**VILLAGE OF WINDSOR
VILLAGE BOARD RESOLUTION 2023-11**

**APPROVAL OF THE PHASE 7 AMENDMENT TO THE DEVELOPMENT AGREEMENT FOR BEAR
TREE FARMS**

WHEREAS, the Village Staff and Consultants have reviewed the Petitioner’s request and prepared a Staff Report dated February 09, 2023 (the “Staff Report”) recommending approval, subject to certain conditions specified in the Staff Report; and

Project No: 122.1386.30
 Sheet C 509

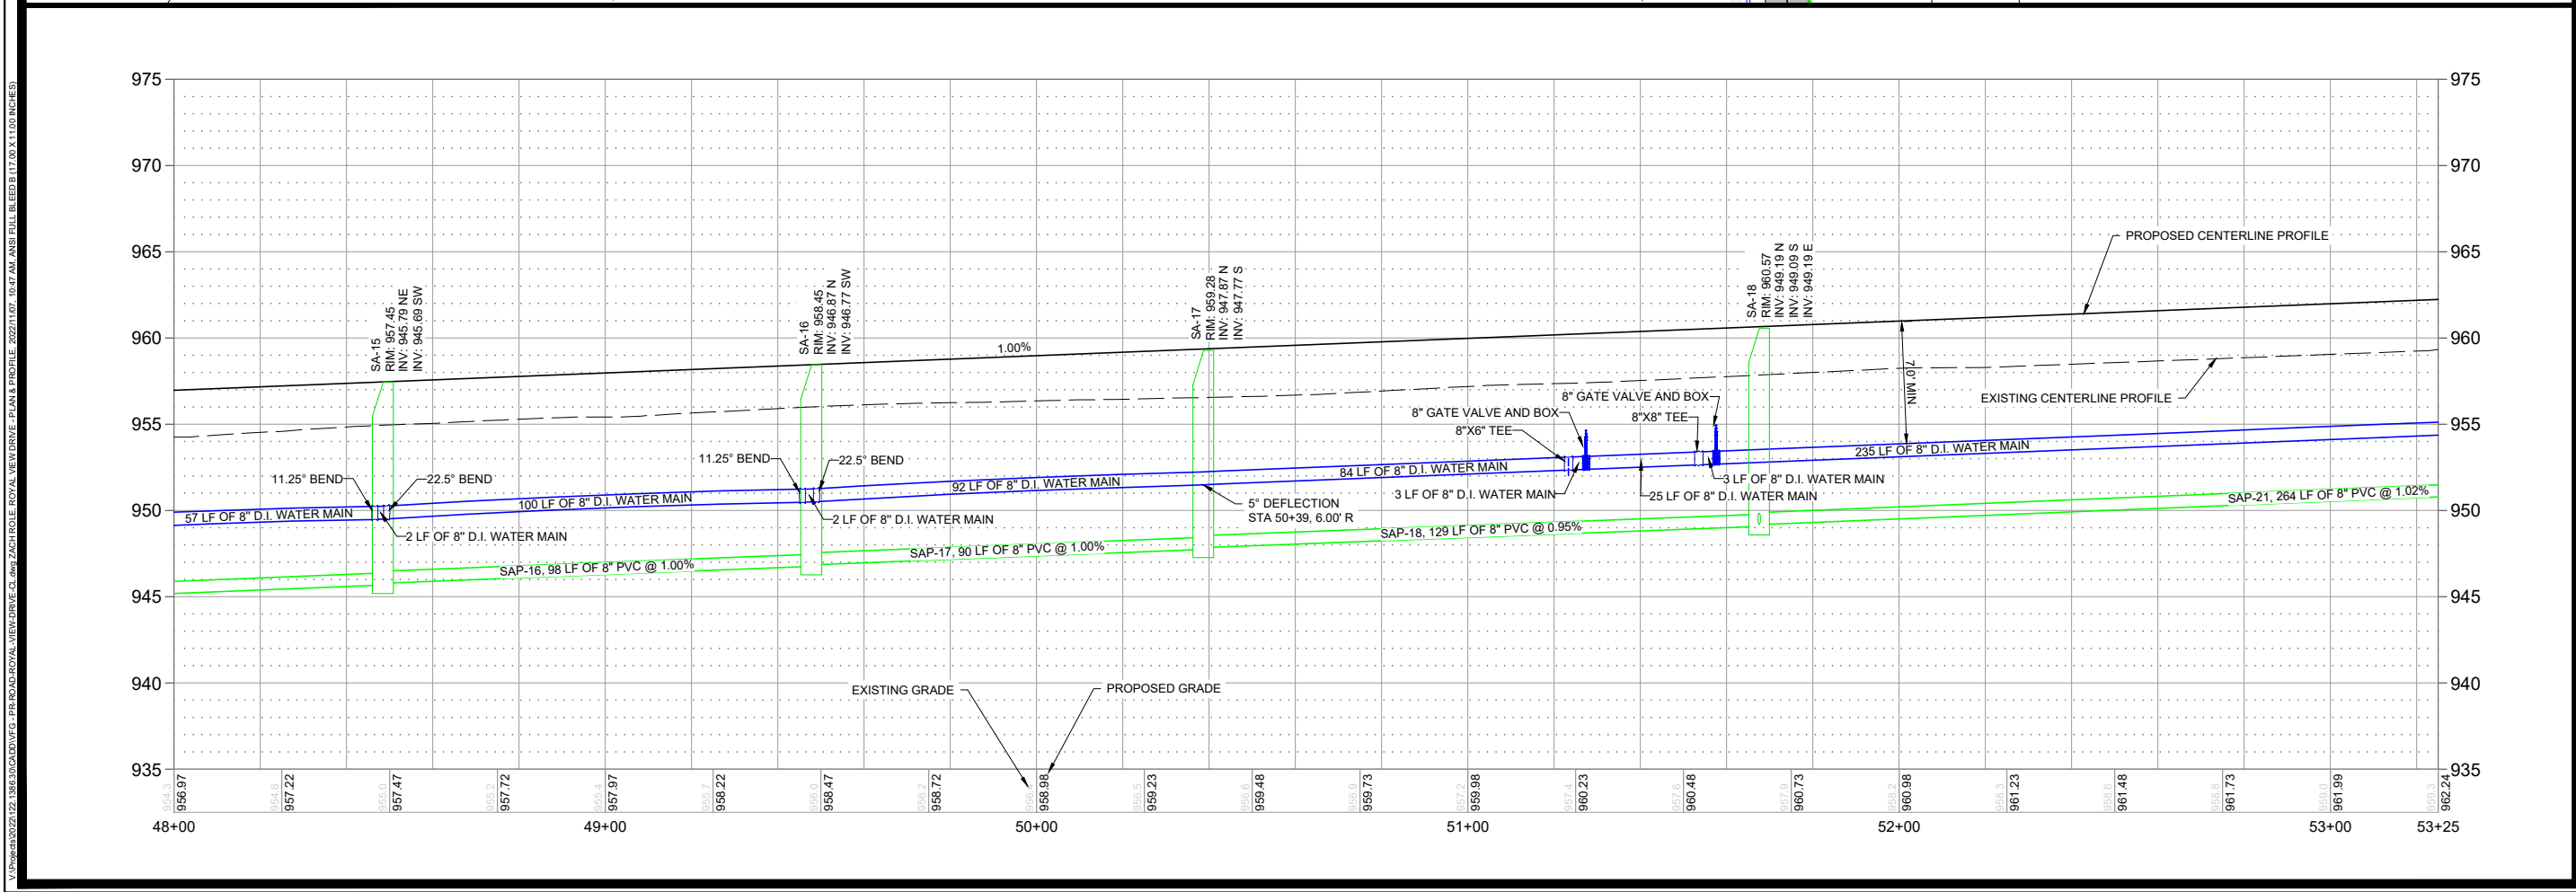
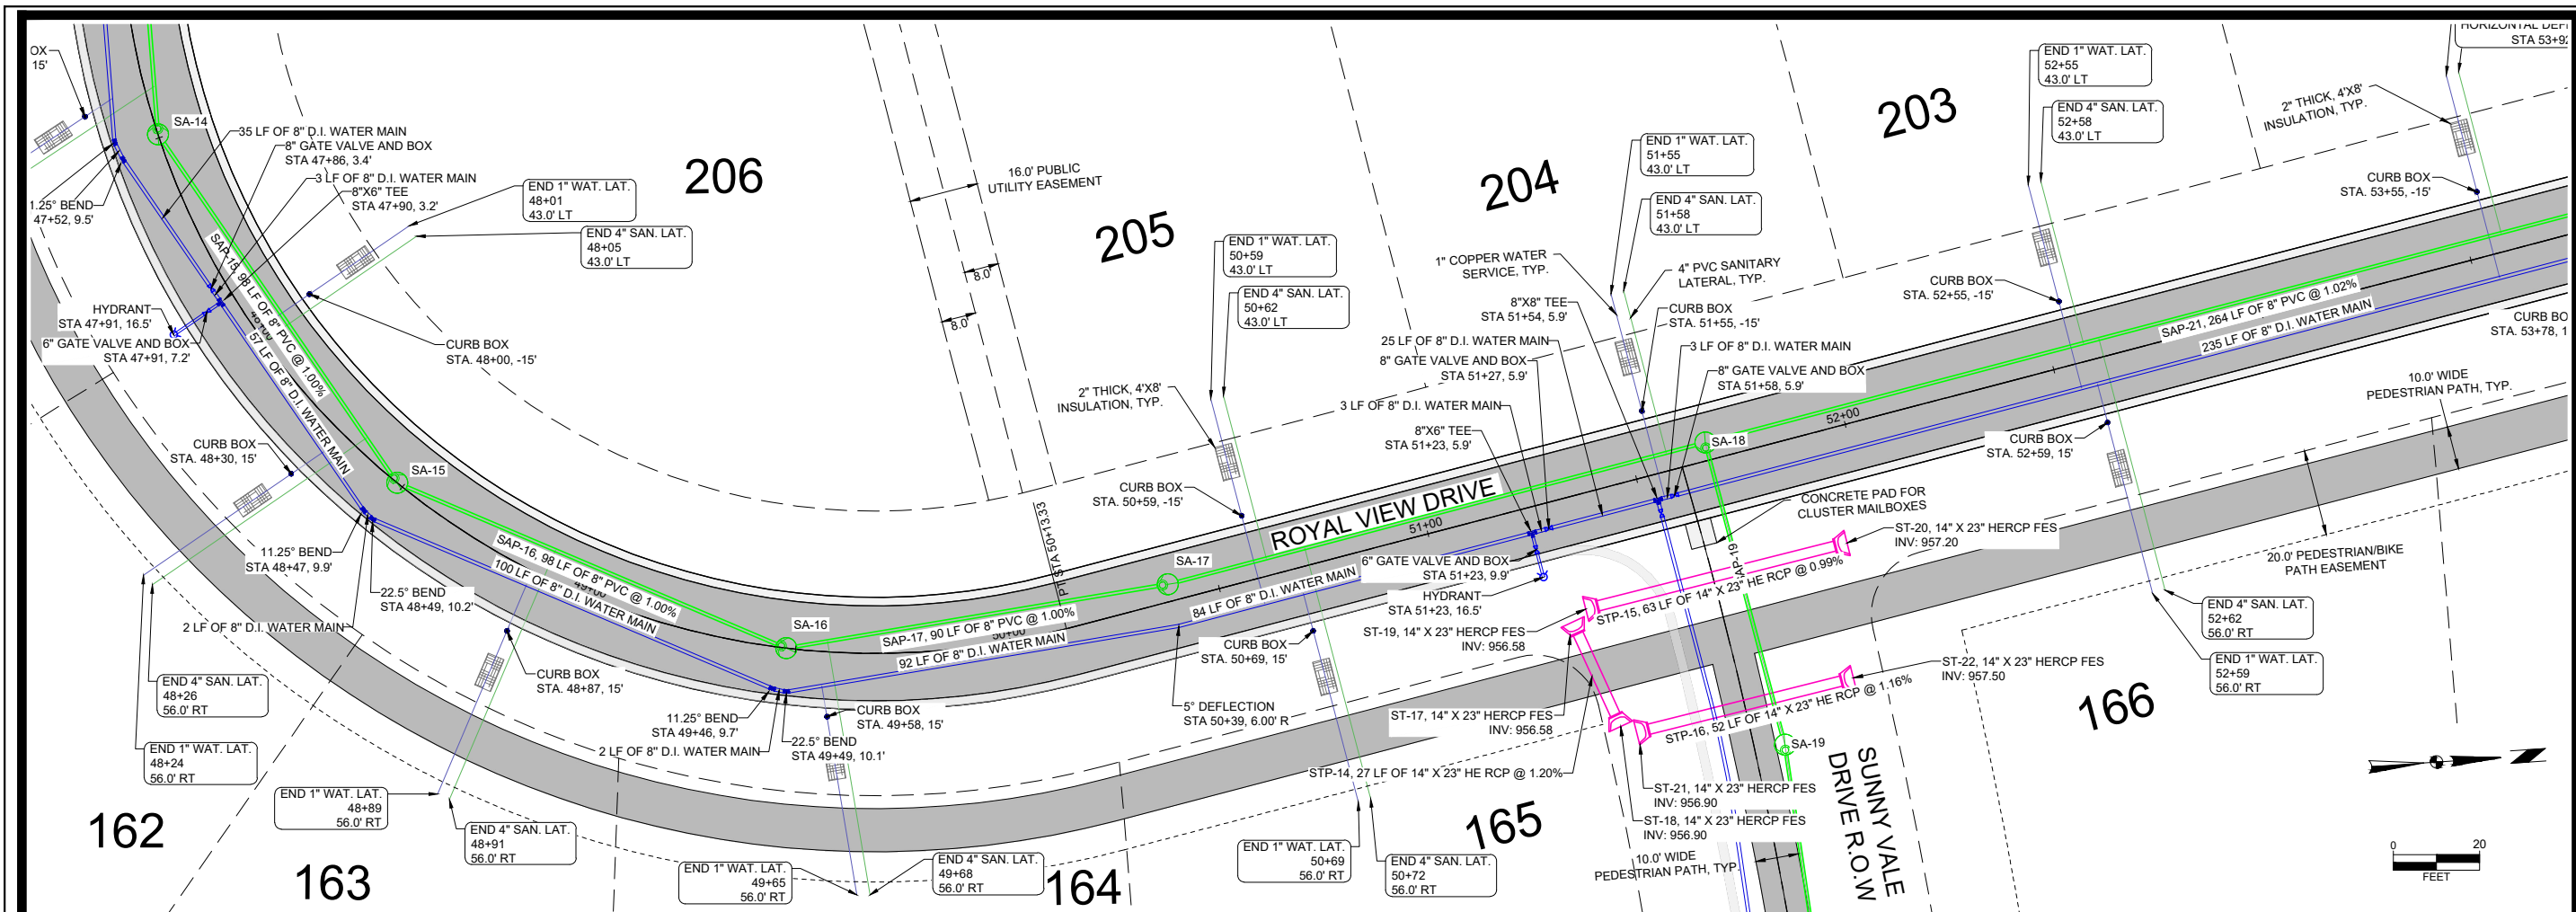
11. Sheet C 509: One side of the water main offset at STA 44+25 should be eliminated, and existing pipe joints be used to aim for the next offset at STA 46+25.

Project No: 122.1386.30
 Sheet C 510

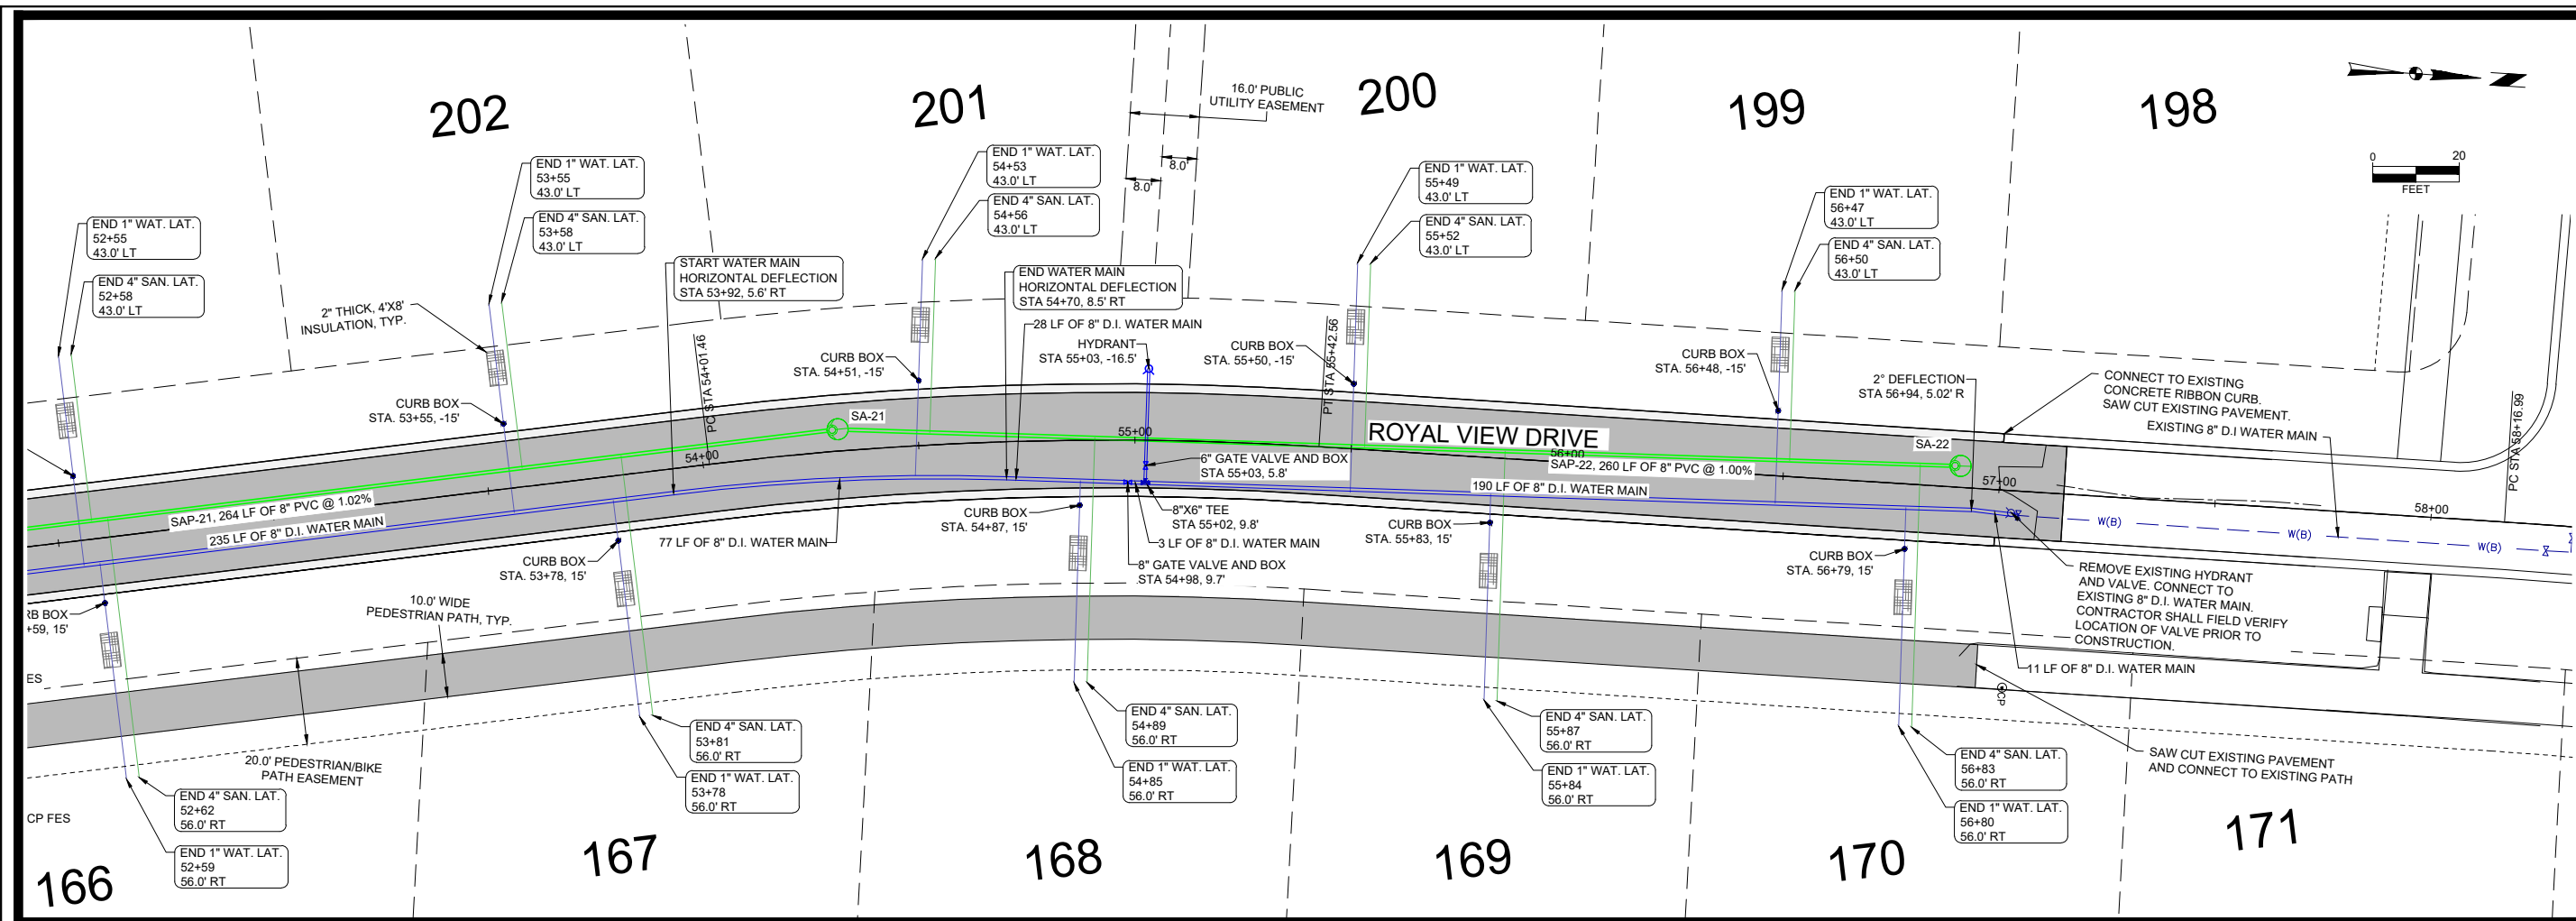
12. Sheet C 510: The cluster mailbox at STA 51+50 is shown in the middle of a future ROW. We suggest the mailbox be moved to be adjacent to the nearby hydrant. This will eliminate the need to potentially relocate the boxes in the future and facilitate easier snow removal for both the hydrant and mailboxes. On a similar note, the path extending down Sunny Vale Drive ROW should connect to the street to allow for snow plows to more easily access the path.
13. Sheet C 703: Add note the water service below the ditch should have a minimum of 5 feet of cover.
